BAYOU BIENVENUE CONTROL STRUCTURE

PERIODIC INSPECTION REPORT NO.7

30 MARCH 1994

SUBJECT: Bayou Bienvenue Control Structure, Periodic
Inspection Report No. 7

PHOTO 1 - Deficient Rip-Rap along banks of the north and south approach channels (Typical)

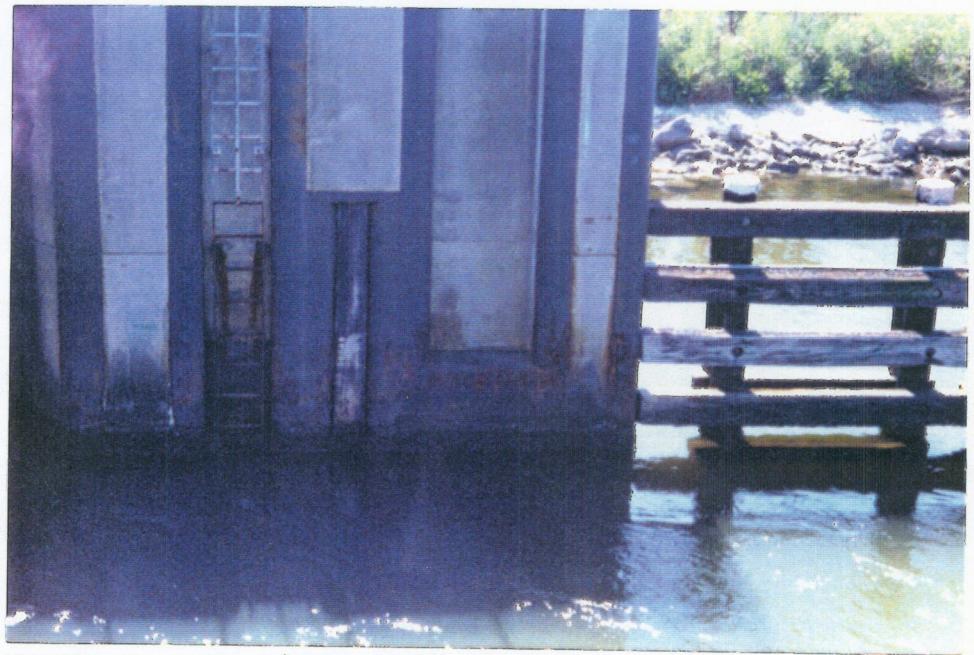
g. Riprap is deficient along the banks of the north and south approach channels behind the guidewalls.

(See Photo 1)

a. Deficient riprap, rusting steel members, termite infested timbers and missing timbers will be replaced or repaired by contract forces.

PHOTO 2 - Rusting steel members

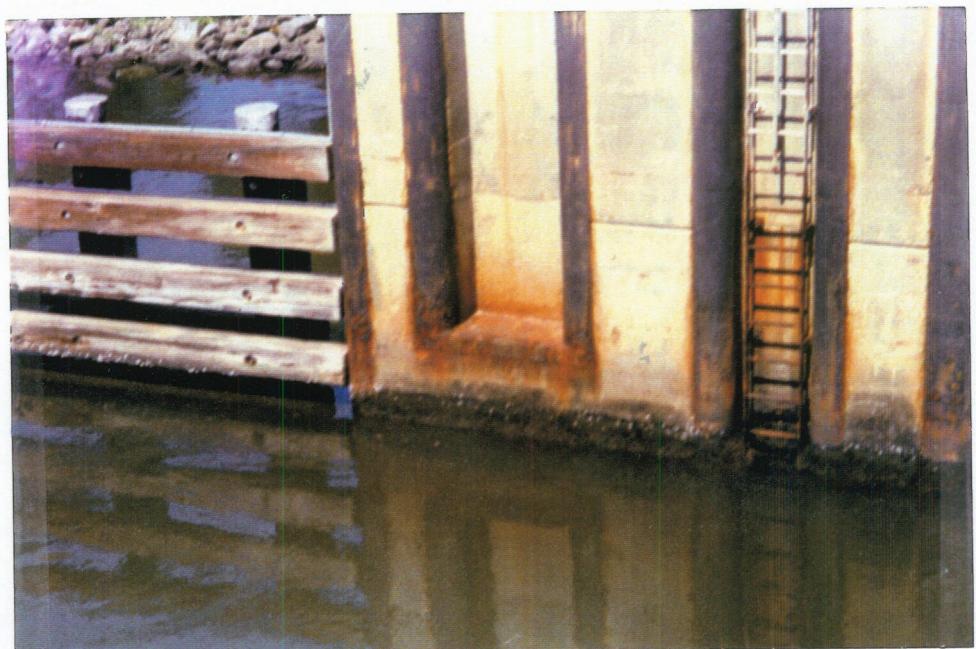
h. Rusting steel members, ladders, corner plates and metal pile caps need repair. (See Photos 2 & 3).
